April 18, 2024

Re: Bureau of Land Management Draft Programmatic Environmental Impact Statement for Utility-Scale Solar Energy Development (89 Fed. Reg. 3687)

Figure 2. BLMs Alternative 3 and 5 make lands available for solar application in the Owyhee Canyonlands that are included in Senator Wyden’s Malheur Community Empowerment for the Owyhee Act.

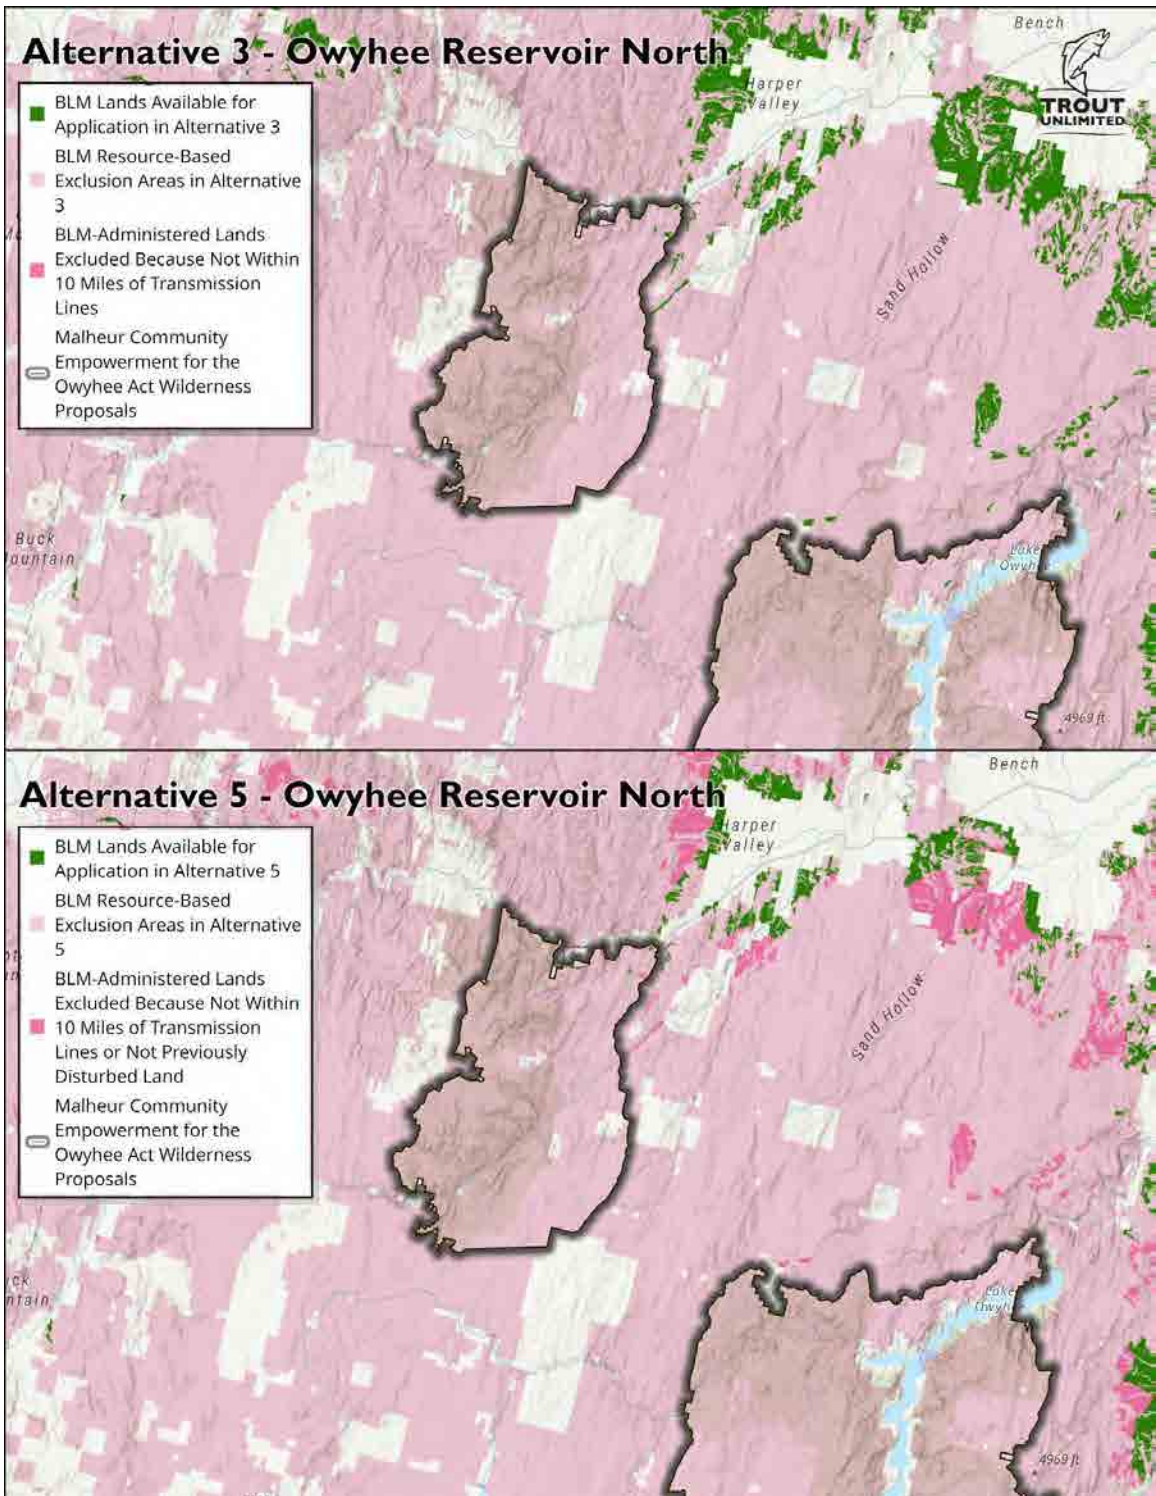
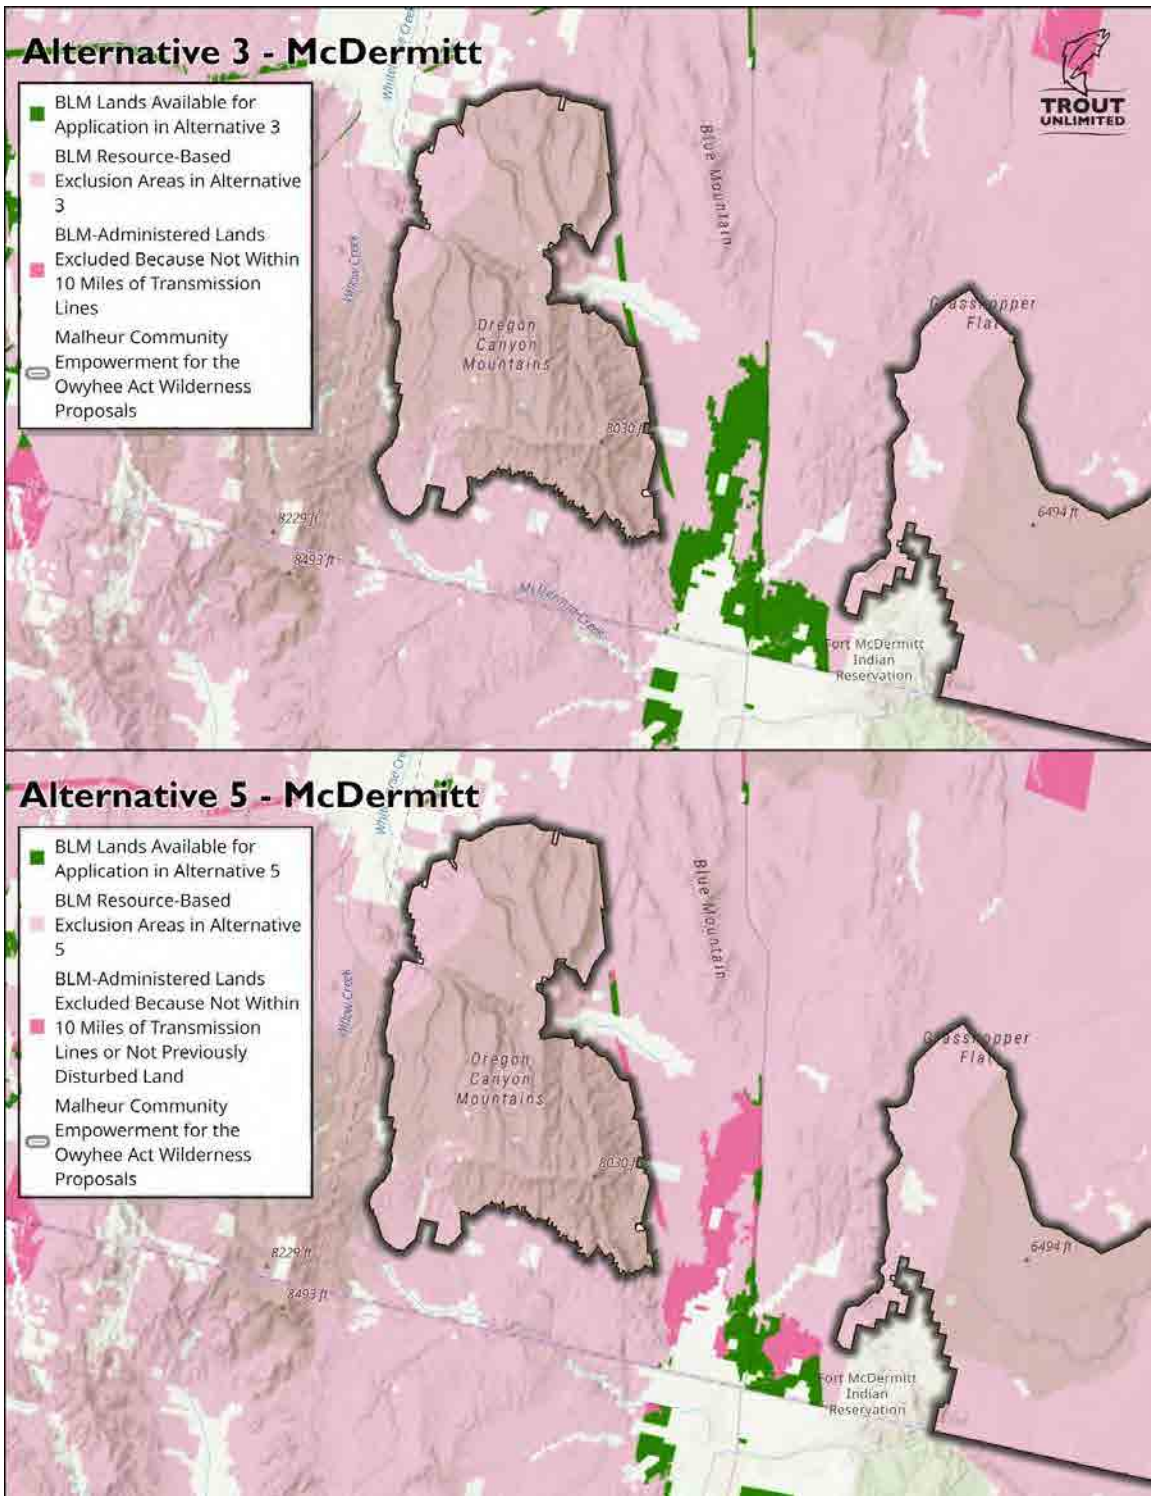
Much of the Owyhee Canyonlands are included in Senator Wyden's Malheur Community Empowerment for the Owyhee Act that would designate roughly one million acres of public lands in the Owyhee as Wilderness. Under BLM Solar PEIS Alternative 3*, lands within and directly bordering the proposed wilderness designation would be available for application for solar development. These areas include lands north of Lake Owyhee, east of the Oregon Canyon Mountains, in the Cottonwood Creek WSA near Red Butte, and along Yapaa Creek (*Alternatives 3 and 5) and Cottonwood Creek south of Highway 20 (Figures 2-3).

Figure 4. Proposed BLM ROW Applicant Process to guide developers to project locations with the least resource impacts.

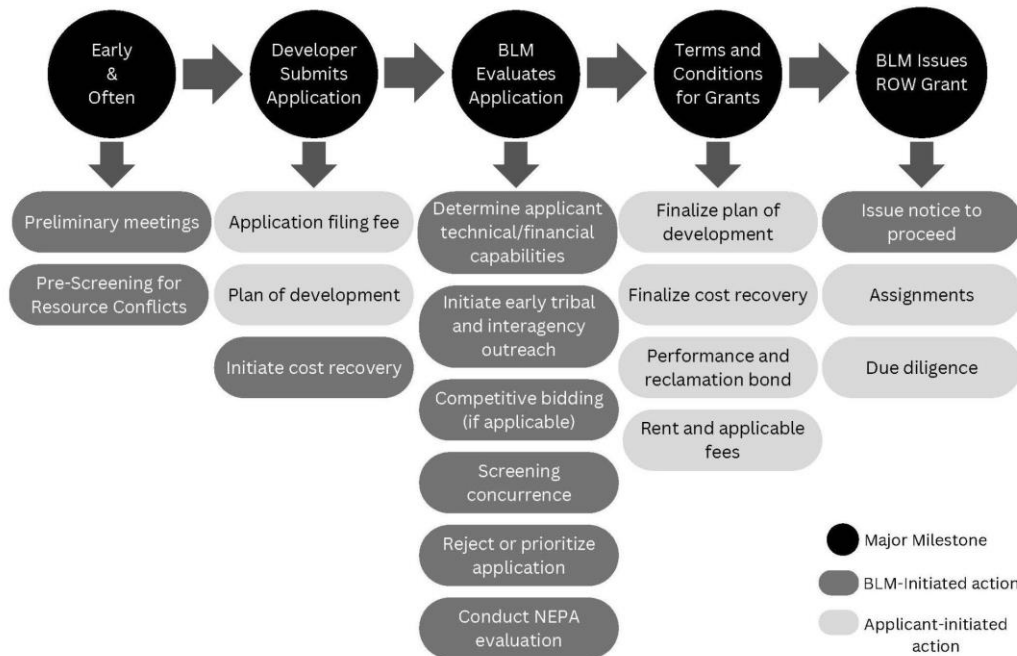
In the Solar PEIS, with the variance process replaced with a screening analysis, a pre-application analysis tool would facilitate more efficient, effective and transparent leasing and permitting. By expecting developers and the BLM to screen projects for potential conflict areas upfront (Figure 4), project proponents and agencies can avoid investing significant resources in problematic applications that could otherwise avoid sensitive areas. Moreover, a pre-application screening tool will assist agencies in identifying and prioritizing those applications that have the fewest resource conflicts, as well as provide constructive feedback that applicants can use to revise proposals in order to ensure the greatest likelihood of success. The BLM should engage state and local governments, including state wildlife agencies, in the pre-screening process. This type of 'early and often' upfront coordination is essential to balance renewable energy development with conservation and avoid mistakes that we have seen with other extractive uses, such as oil and gas leasing. Additionally, the PEIS should use the prioritization and screening approach outlined in Instruction memoranda (IM) 2022-017 and 2023-015, including the initial screening criteria and prioritization checklist in IM 2022-017, as a basis for any unmapped priority area framework.

Figure 6. Example of the multispecies assessment for ranking Western coldwater habitats overlaid with BLM’s Alternative 3.

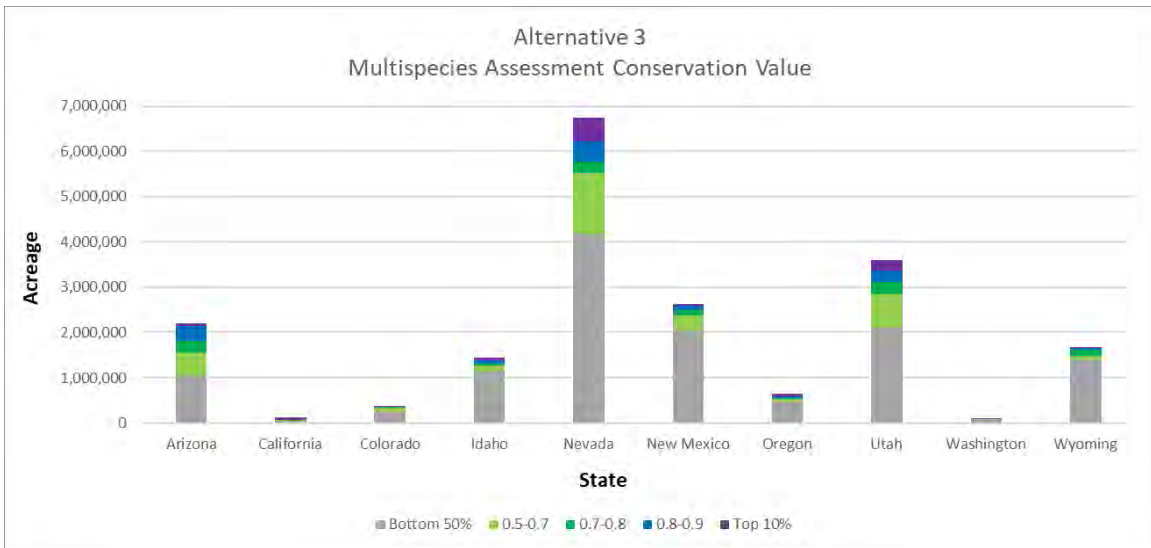
Given that there is substantial overlap with these important aquatic habitats and other resources analyzed in the PEIS we believe that BLM should be able to make this adjustment in the final PEIS.

Figure 1. BLM's Solar PEIS Alternatives 3 and 5 would make BLM land along the mainstem Deschutes River, Lake Billy Chinook, Oregon available for solar application.

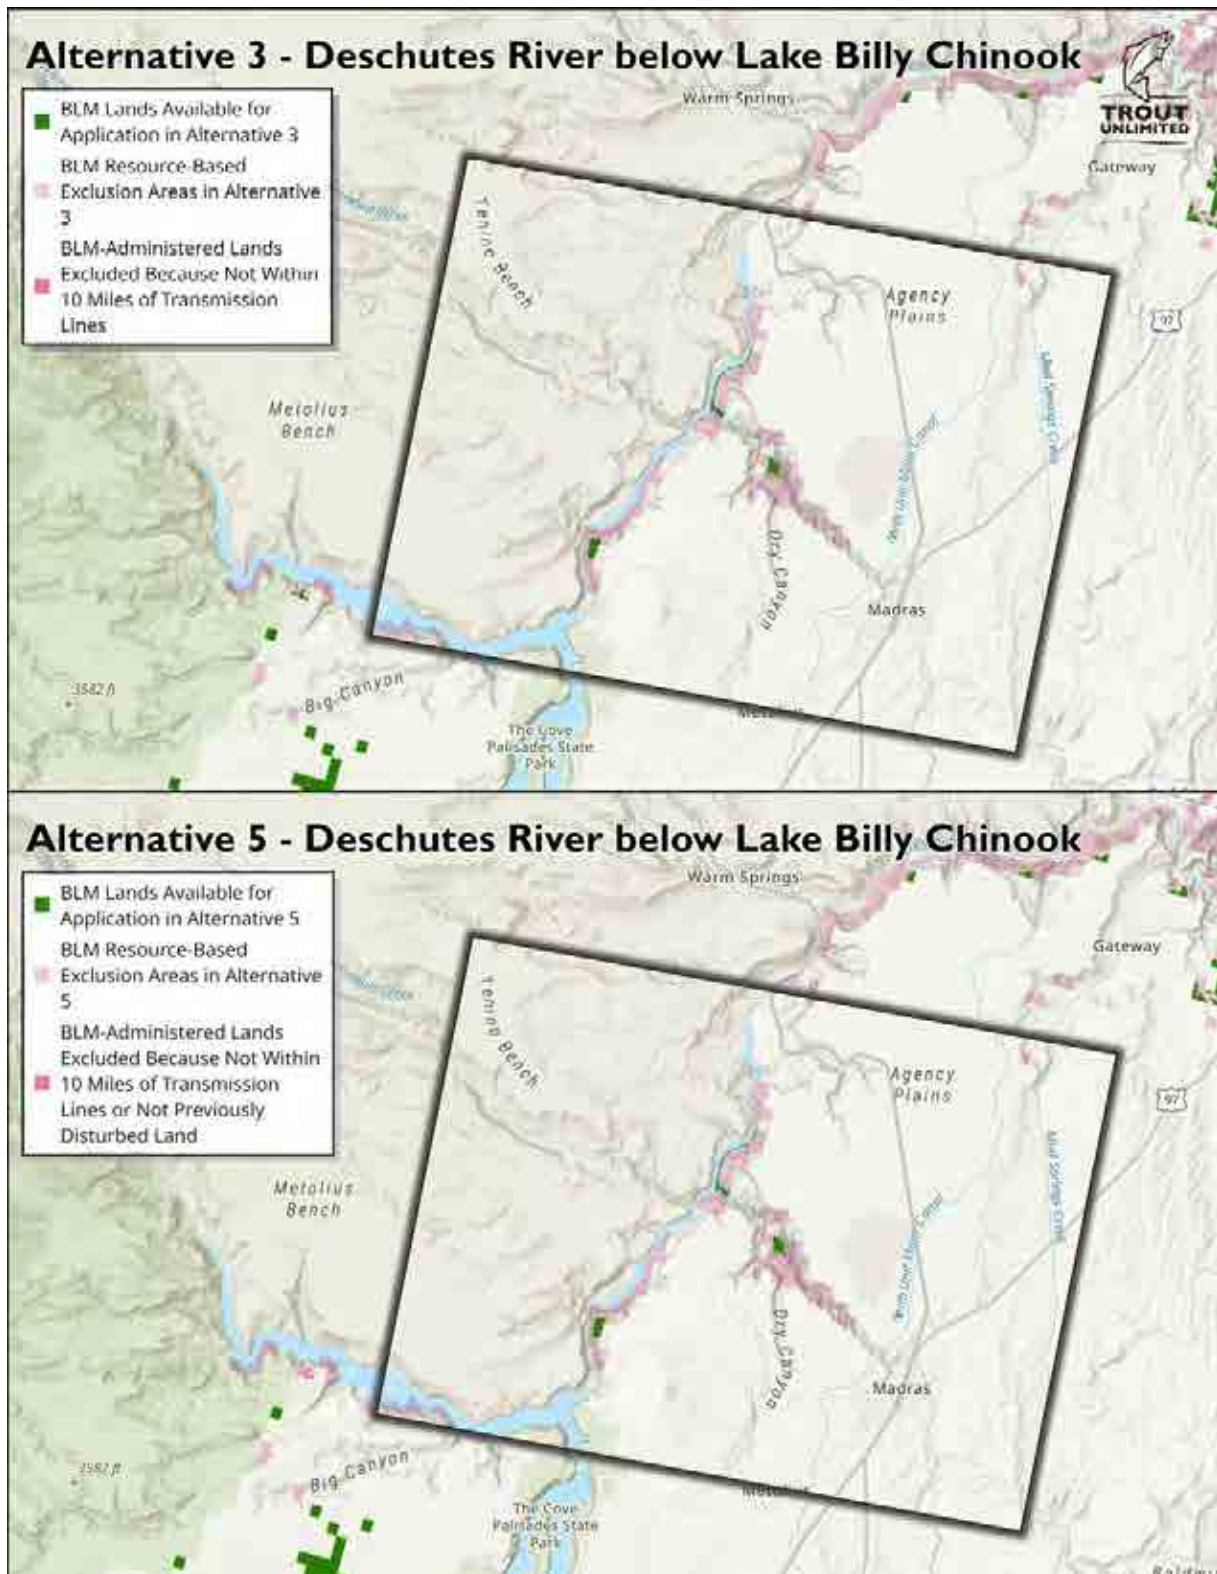
The Deschutes River, Oregon should be closed to utility-scale solar. Oregon's Deschutes River is the most fabled trout water in the state and supports a wide range of recreational activities including fishing, rafting, hunting, mountain biking, and hiking. The Deschutes River Basin drains much of the east side of Oregon's Cascade Mountains, gathering tributaries such as the spring-fed Metolius River, snowmelt-driven Crooked River, and glacial-origin White River, on its path northward to the mighty Columbia River. The iconic Deschutes is home to a wide variety of native salmonids including redband trout, bull trout, summer steelhead, spring and fall Chinook salmon, and coho salmon.

BLM's Solar PEIS Alternatives 3 and 5 would make BLM land along the mainstem Deschutes River, Lake Billy Chinook (Figure 1) and key Deschutes River tributaries including Trout Creek (Figure 2), Wapinita Creek (Figure 3), and the Crooked River (Figure 4) available for application for solar development.
